# Rampion 2 Wind Farm

### Outline Construction Traffic Management Plan (clean)

**Date: August 2024**

**Revision G**

Figure 7.6.4d Temporary construction and operational accesses

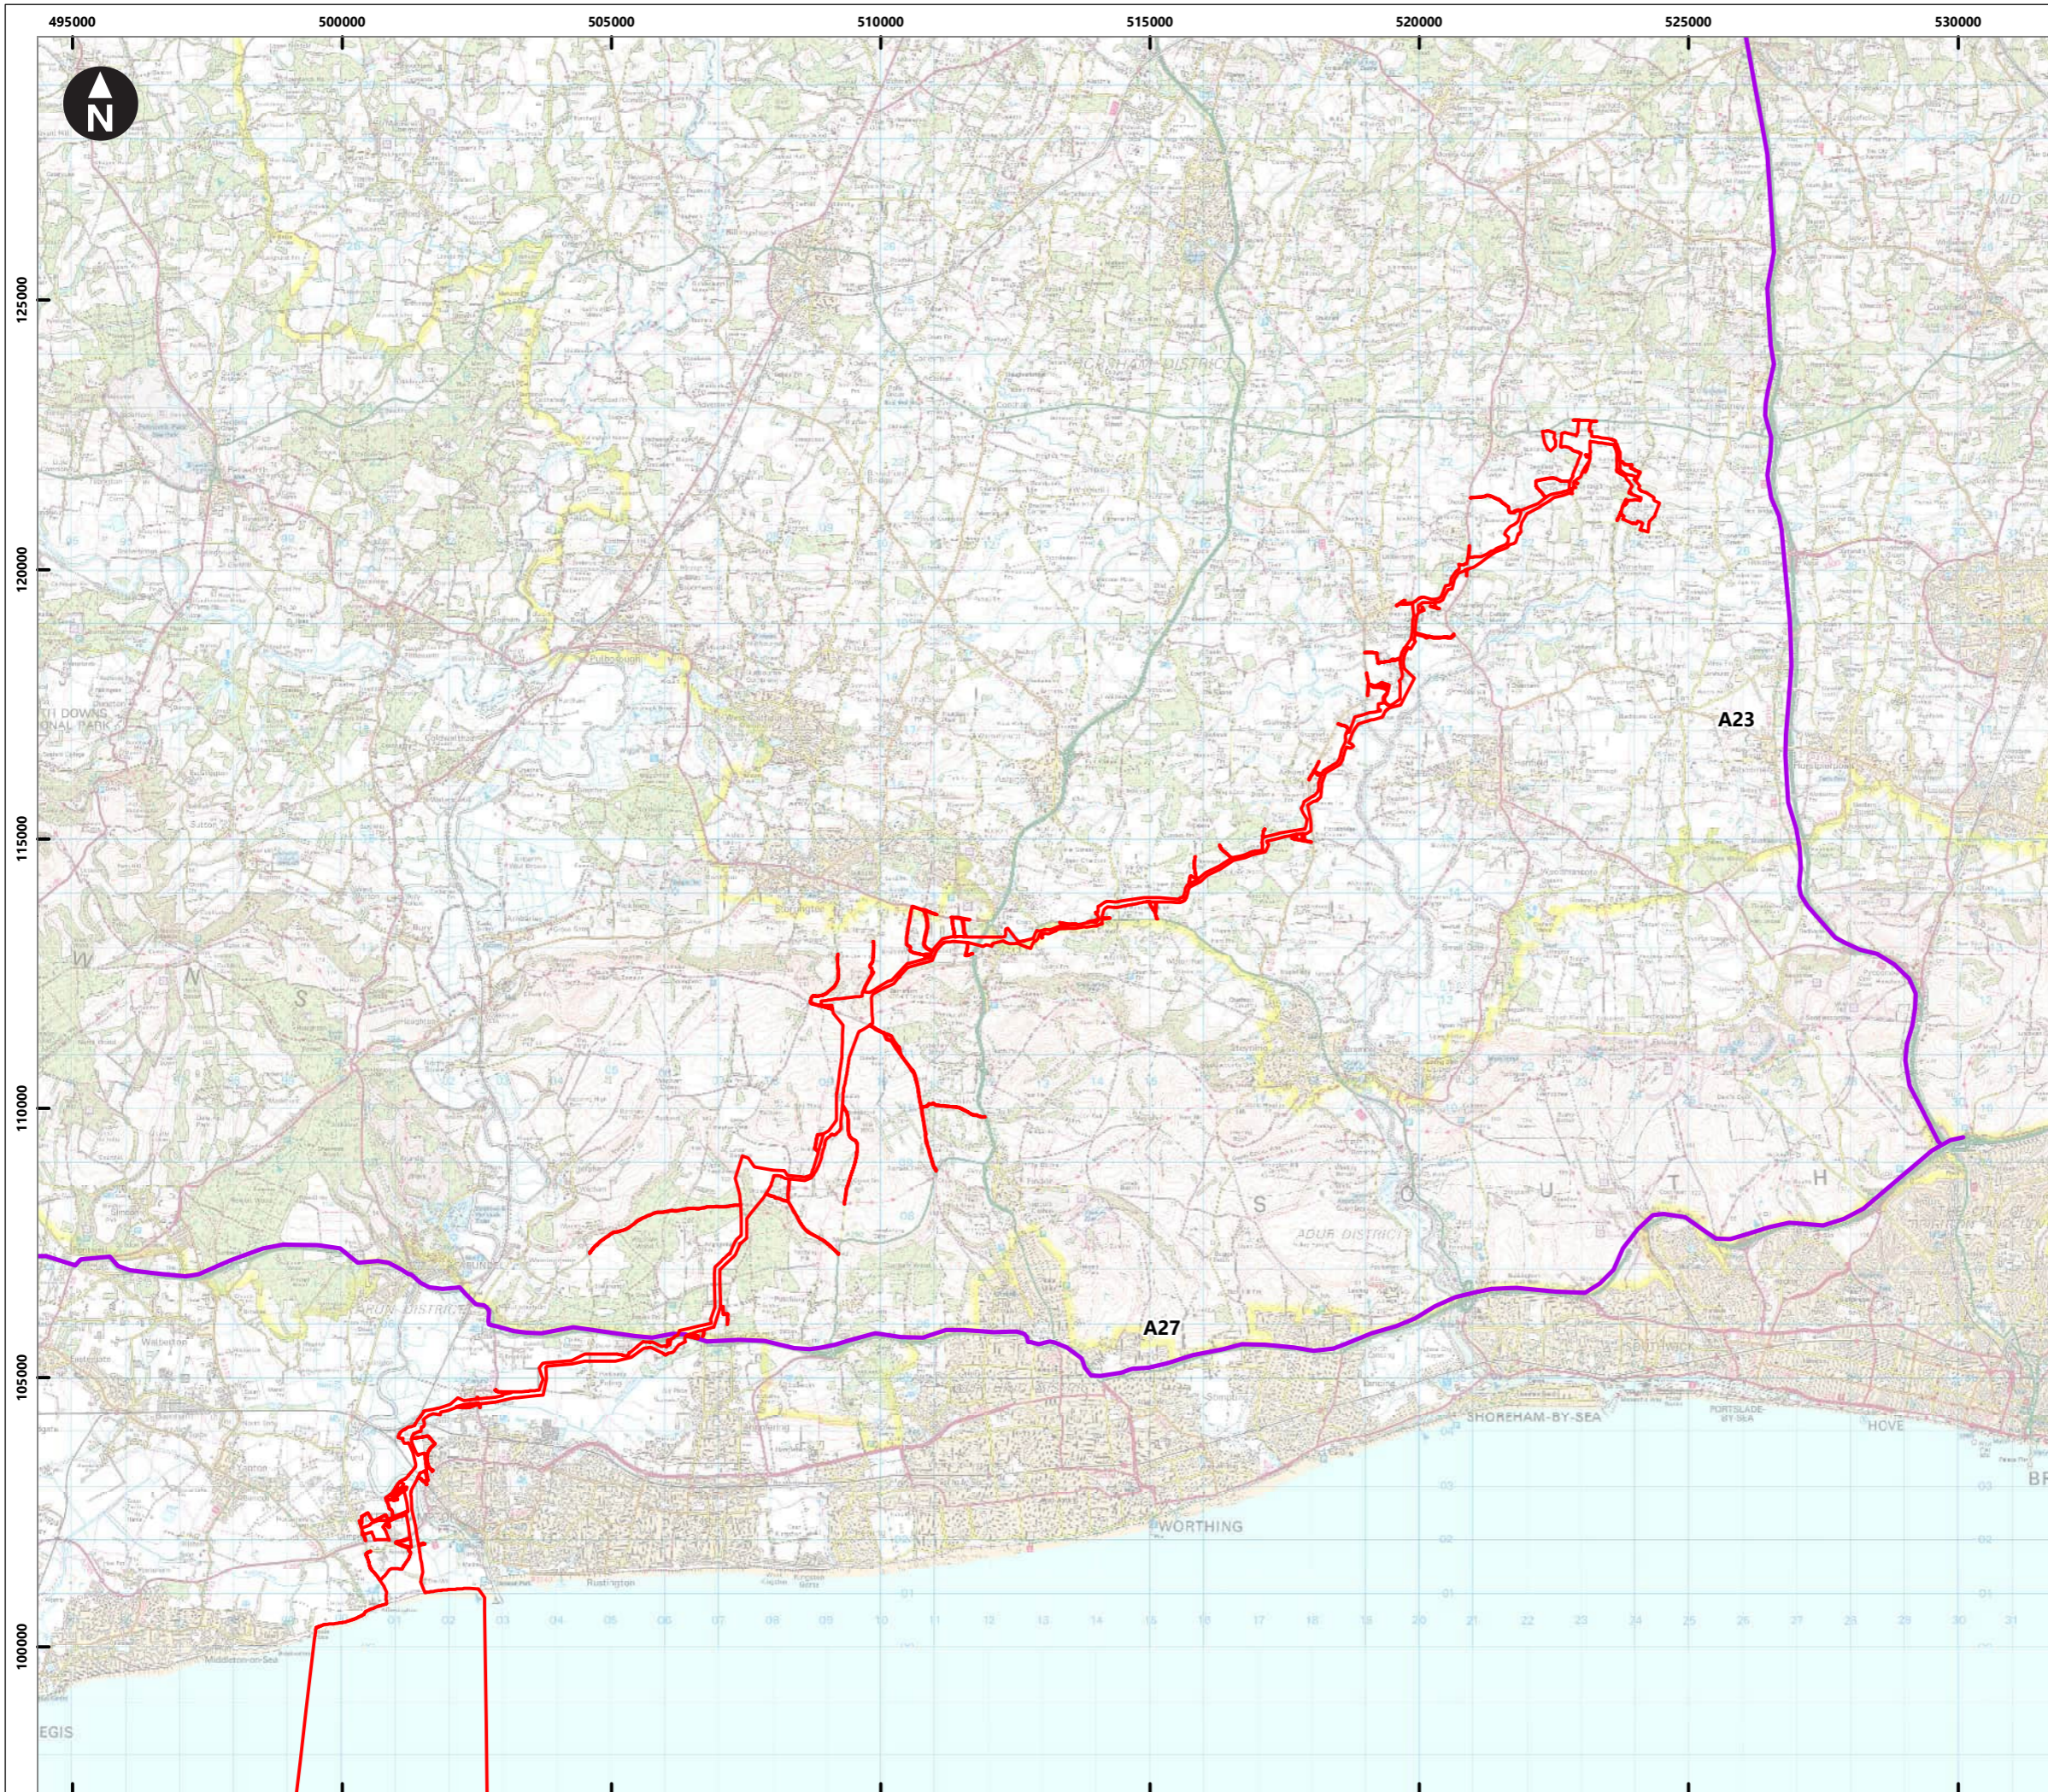
WSSC Local Impact Report Comment	Recommended Action	Applicant's Response to WSSC Local Impact Report	Applicant's amendment to the Outline CTMP
<p>Appendix B, Figure 7.6.4d Temporary Construction and Operational Accesses</p> <p>The access tracks leading from the B2135 at A56 and A57 (construction and operational) are narrow. This could cause vehicles to queue back onto the highway.</p>	<p>Passing places should be provided on the access tracks to enable two vehicles to pass. Alternately traffic management measures may be required to avoid conflicting movements.</p>	<p>[PEPD-009] the Applicant will include additional wording to reflect West Sussex County Council's comments within Appendix B of the <b>Outline Construction Traffic Management Plan [REP1-010]</b>. This will be included in an update to the <b>Outline Construction Traffic Management Plan [REP1-010]</b> at Deadline 3.</p>	<p>Additional wording added to <b>Appendix A</b> under Access A-56 and A-57.</p>

WSCC Local Impact Report Comment	Recommended Action	Applicant's Response to WSCC Local Impact Report	Applicant's amendment to the Outline CTMP
<p>Appendix B, Figure 7.6.4d Temporary Construction and Operational Accesses</p> <p>A67 (construction and operational) and A68 (construction) are both existing. There are no concerns with the accesses themselves, but measures will be required along Wineham Lane to mitigate the additional construction traffic. This may also require measures at the A272 Wineham Lane junction.</p>	<p>Measures will be required to control and avoid conflicting vehicle movements along Wineham Lane Additional measures should be included to assist exiting HGVs both at the Wineham Lane accesses but also at the A272 Wineham Lane junction. Signage may also be required to alert drivers on the A272 to the presence of exiting/turning HGVs. HGV movements should be timed to avoid the network peak hours where possible.</p>	<p>At peak construction the Proposed will generate approximately 40 heavy goods vehicle (HGV) movements per day, which is the equivalent of 3-4 vehicles per hour or one every 15-20 minutes. Based on these peak construction traffic estimates, it is unlikely that the majority of existing traffic will meet an HGV traveling between the A272 and construction site. It is also noted that Wineham Lane has a suitable carriageway width to allow general traffic to pass HGVs on the rare occurrences this occurs. Notwithstanding the above, the Applicant will review this request and provide an update to the <b>Outline Construction Traffic Management Plan [REP1-010]</b> at Deadline 3 where appropriate.</p>	<p>Additional wording added to <b>Appendix A</b> under Access A-67 and A-68 to reference the requirement for a temporary 40mph speed limit on Wineham Lane, which is also included in <b>Section 8.2</b>.</p>

Rampion 2 Offshore Wind Farm  
 Figure 7.6.6b Local Access Routes  
 Outline Construction Traffic Management Plan

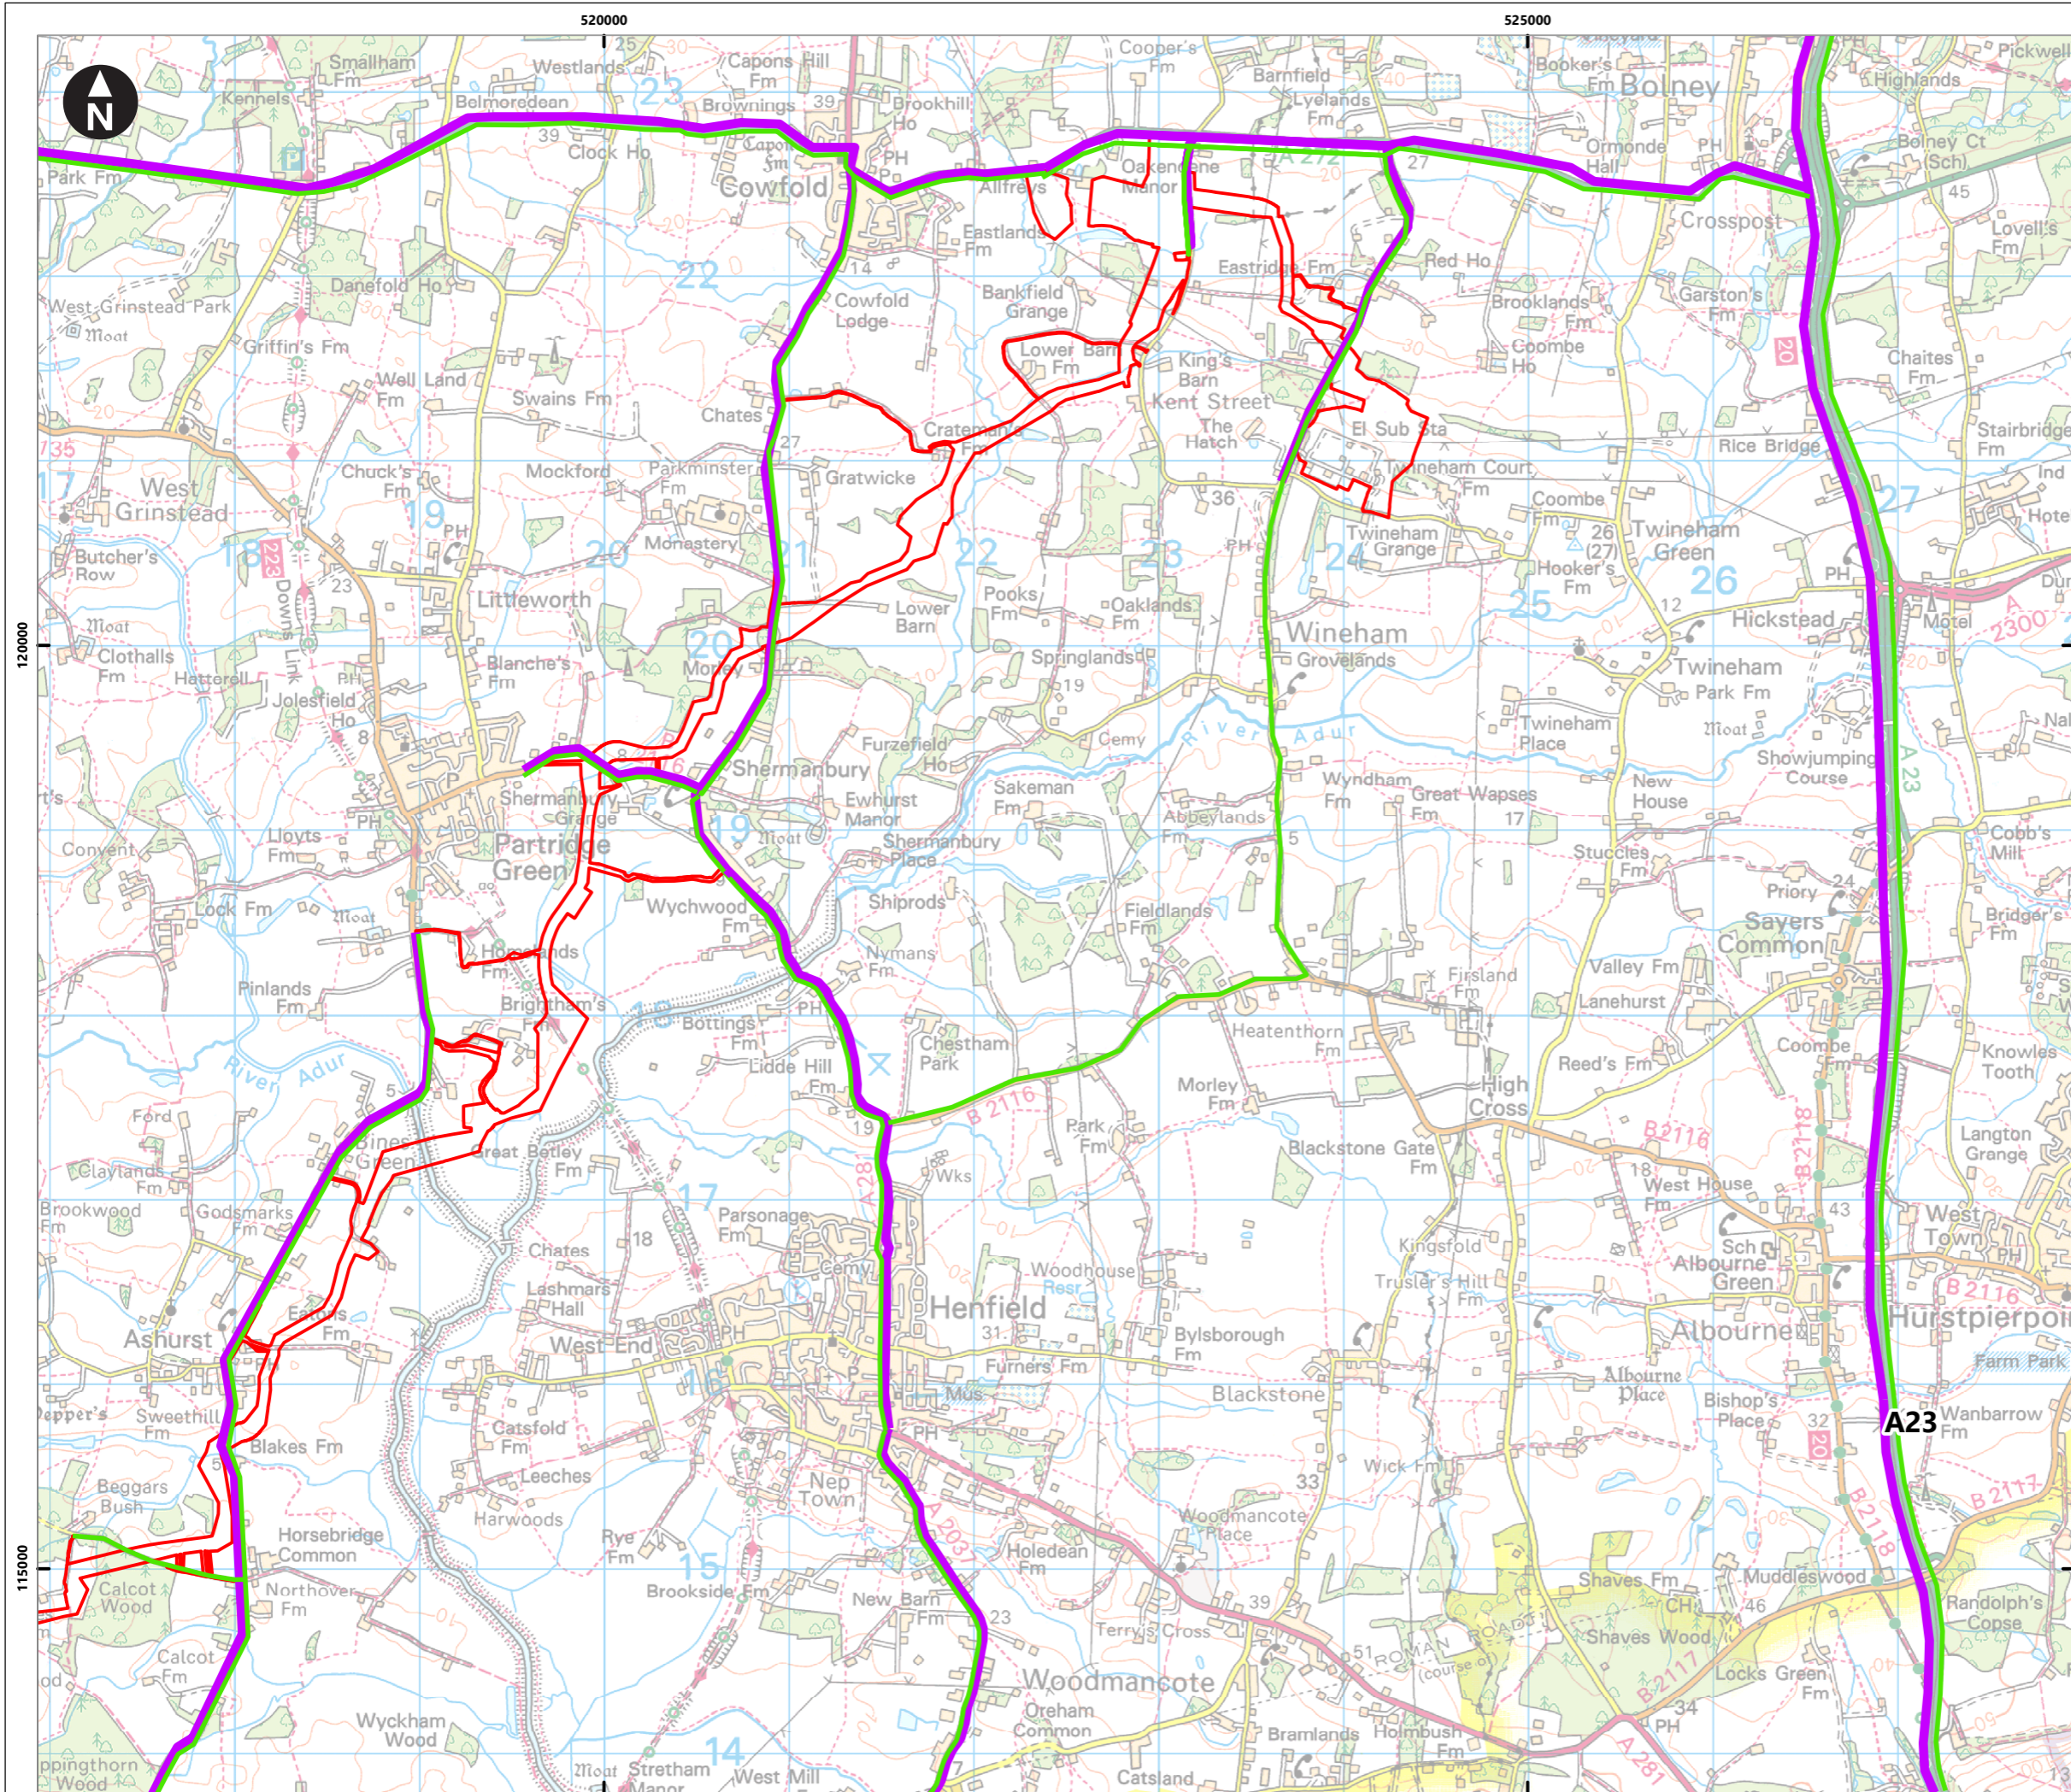
Stakeholder comment	Applicant's response	Applicant's amendment to the Outline CTMP
<b>Horsham District Council [REP4-084]</b>		
<p>Figure 7.6.6b Local Access Routes (Outline Construction Traffic Management) shows that Storrington AQMA is a potential route for LGVs. Horsham District Council rejects routing of vehicles through Storrington. The Storrington AQMA is the only monitoring site in the district that is still recording concentrations within 10% of the annual mean objective. There are other viable alternative routes for LGVs to access the Washington compound and there should be no need for LGVs to go through the AQMA.</p> <p>Although the HGV are not proposed to go through the AQMA, there is a proposed HGV route on the A283 that leads to Storrington. More information regarding the number of HGV on this proposed route is required and also on how HGV use will monitor and controlled by the Project Team.</p>	<p>Figure 7.6.6b of the <b>Outline Construction Traffic Management Plan [REP4-045]</b> shows potential light goods vehicle (LGV) routes to site based upon journey to work information derived upon Census 2011 data. Given that the route through Storrington uses the A283 this is considered the most appropriate route for construction workers traveling to site from areas to the west. Further to this, Table 2-15 within <b>Chapter 32: ES Addendum, Volume 2</b> of the Environmental Statement (ES) <b>[REP1-006]</b> updated at Deadline 5 shows an estimated peak week construction traffic flow of approximately 150 vehicles day at Receptor O (A283 Storrington Road, Northeast of Sullington Lane), equivalent to less than a 1.0% increase in baseline traffic flows. Noting this estimate includes LGVs associated with access A-33, the number of construction traffic vehicles passing through Storrington will not be significant.</p> <p>In relation to HGVs, the A283 west of access A-33 is not a permitted HGV route. This is shown on Figure 7.6.6b of the <b>Outline Construction Traffic Management Plan [REP4-045]</b>. Further to this, Appendix A of the <b>Outline Construction Traffic Management Plan [REP4-045]</b> defines that</p>	Not applicable.
